1 August 2018

Our Ref: 18-111

RE: S4.55(1A) MODIFICATION APPLICATION (4) TO SSD 14_6848 IN RELATION TO THE STAGE 3B DEVELOPMENT AT LISMORE BASE HOSPITAL

Figure 2 Proposed amended L03 Floor Plan (Source: Conrad Gargett)

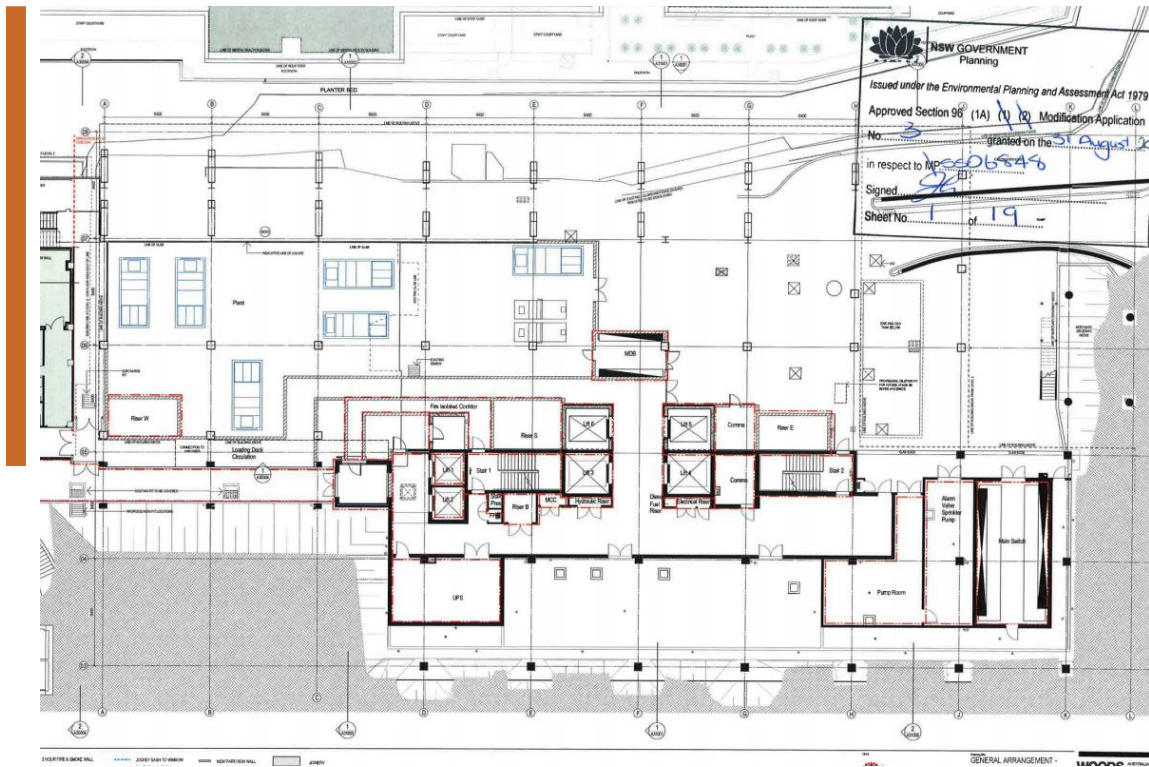
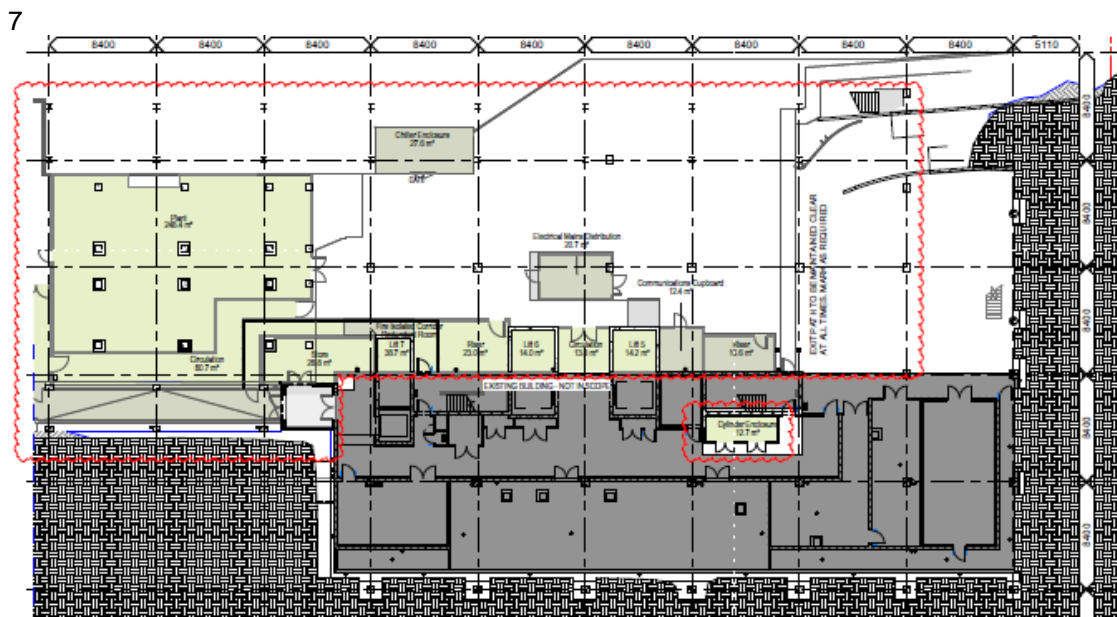
- Reduction in the extent of plant at Level 03, noting that some of this plant has been relocated to Level 07 (within the NTX, the subject of SSD 17_8963). The use of this area for maintenance will remain unchanged. Refer to the figures on the page over for a comparison between the approved and proposed amended floor plan for Level 03:

Figure 4 Proposed amended L04 Floor Plan (Source: Conrad Gargett)

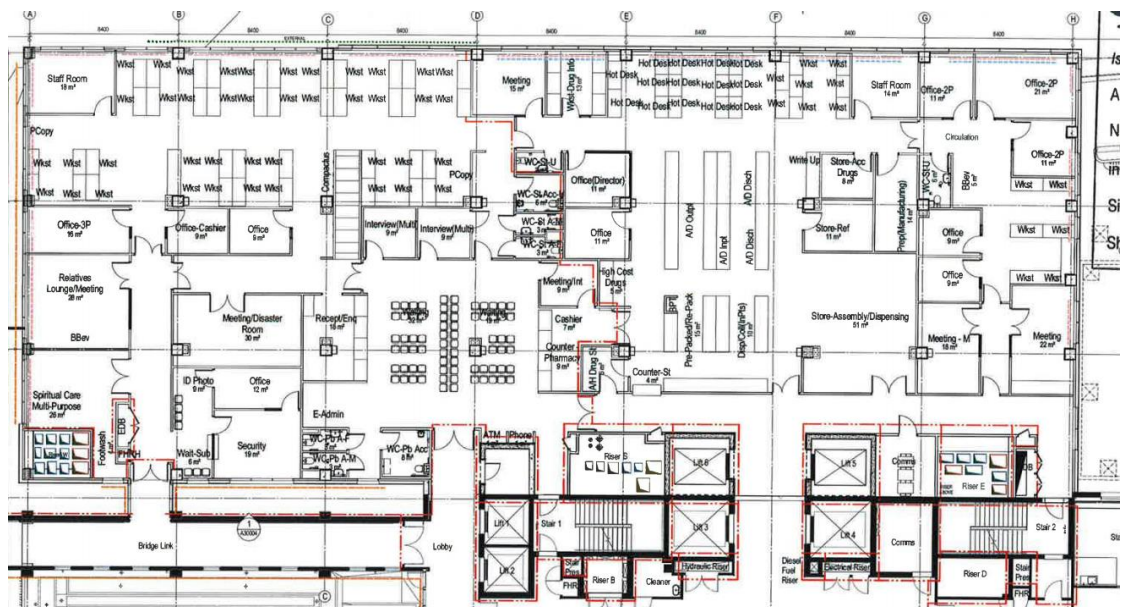
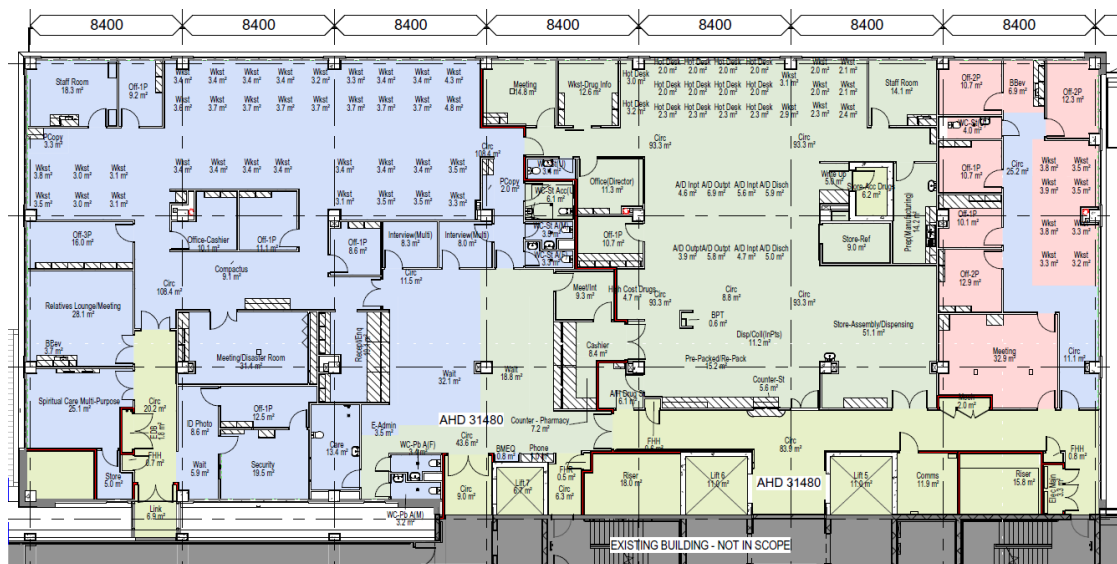
- Minor modifications to the internal layout of Levels 04, 05 and 06, including:
 - Rationalisation of fire compartmentation and overall strategy;
 - Inclusion of an additional public lift within an approved void/shell space (known as “lift 7”);

- Minor modifications to the internal planning of each level to improve functional efficiency, accommodate service risers and penetrations to the future NTX and to respond to changes in the location of columns/structural beams; and
- Modifications to the internal face of the external walls as a result of layout changes (such as rationalisation of number of partitions) and the amended façade design (i.e. extent of glazing vs. infill).

Figure 8 Proposed amended L06 Floor Plan (Source: Conrad Gargett)

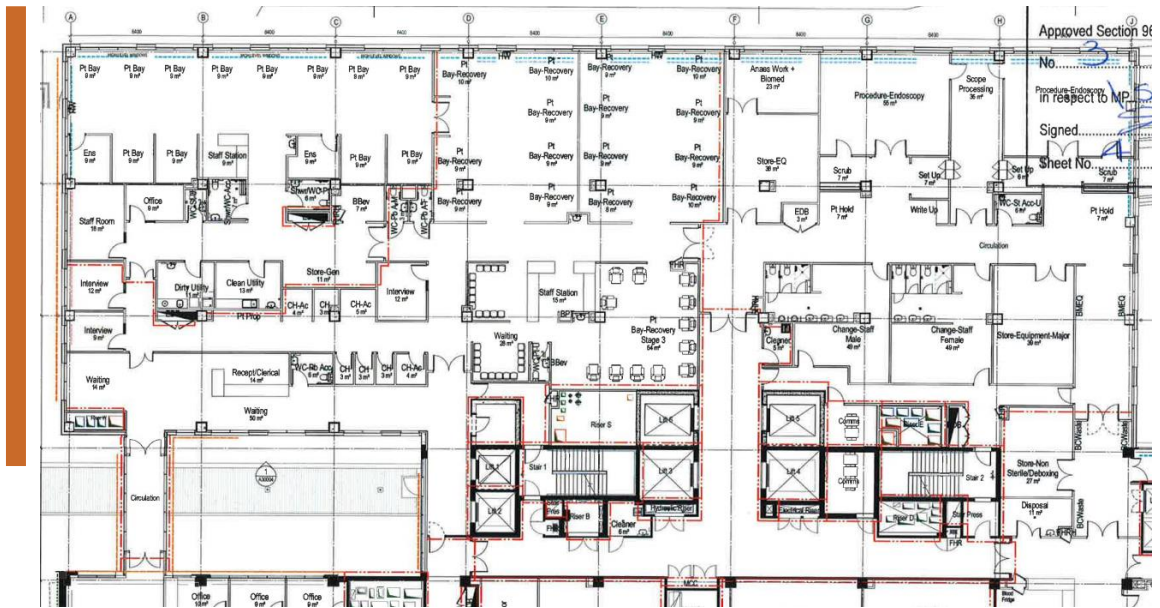
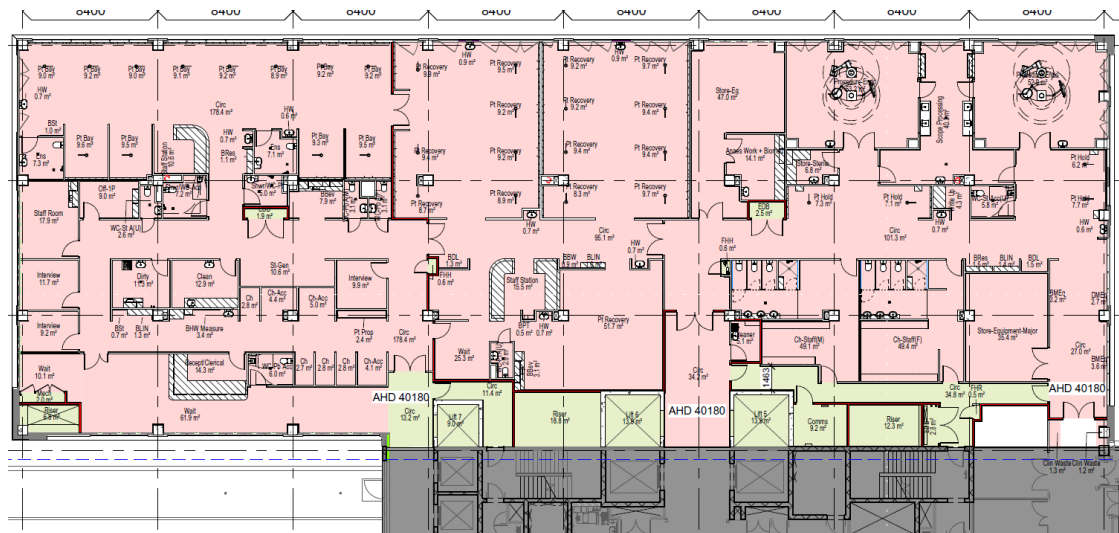
- Removal of the approved link bridge to Level 06, connecting the two (2) towers (this can be seen in the two (2) figures above).
- Amendments to the external façade design and colour scheme of the Stage 3B2 North Tower, as follows:
 - Amelioration of design language and window placement to the façade (to suit internal layout);
 - Change of the façade colour palette to muted/varied greys. Whilst the colour scheme is proposed to be amended, the materials and finishes will remain unchanged;
 - Incorporation of quench pipe box and large removable window for MRI; and
 - Extent of louvre panelling reduced at Level 03 as a result of the proposed reduction in plant space.

Figure 9 Approved vs Proposed Northern Elevation of Stage 3 (Source: First image Woods Bagot & second image Conrad Gargett)

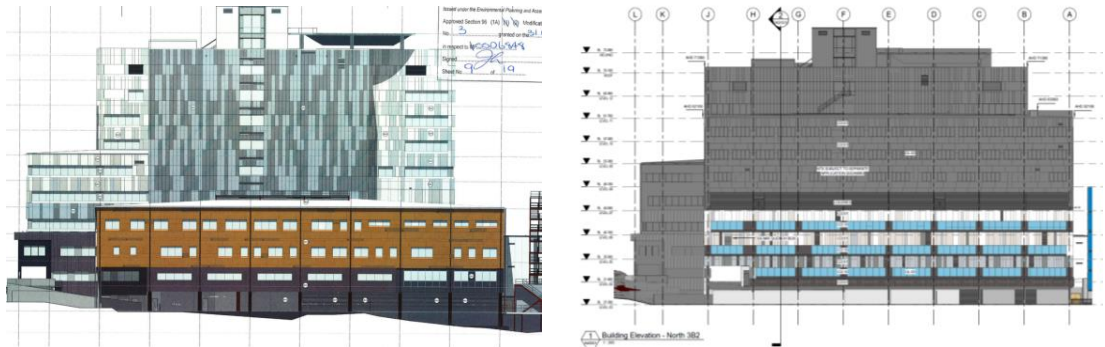
Refer to the elevation plans below for a comparison between the approved façade design of the Stage 3B2 North Tower, versus the proposed façade design. We note that the amended elevation plans include the Stage 3C North Tower extension NTX development which is greyed out and annotated on the plans as being subject to a separate SSDA (SSD 17_8963):
